2 Type of change

- Change of markings
- Modified packaging label

Product Change Notification					KEA and KEA-Print power entry module		
owner	creation date	release date	released by	change order no	rev	page	D10-032-663
sariogar	11.12.2018	25.03.2019	blumhe	2016811	A	1 of 4

KEA and KEA-Print power entry module

KEA screw-on mounting unwired

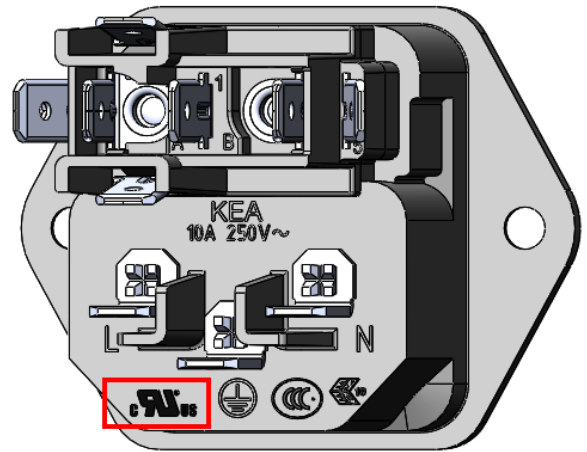
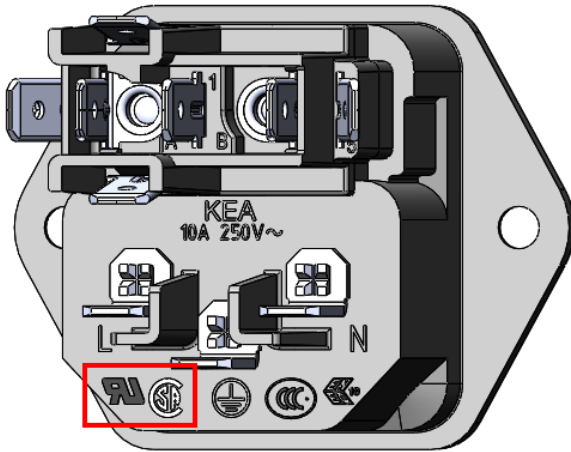
Standards update according to the new UL/CSA 60320-1.
When KEA-Print versions approval marks are covered by the ground terminal, the markers are shifted.
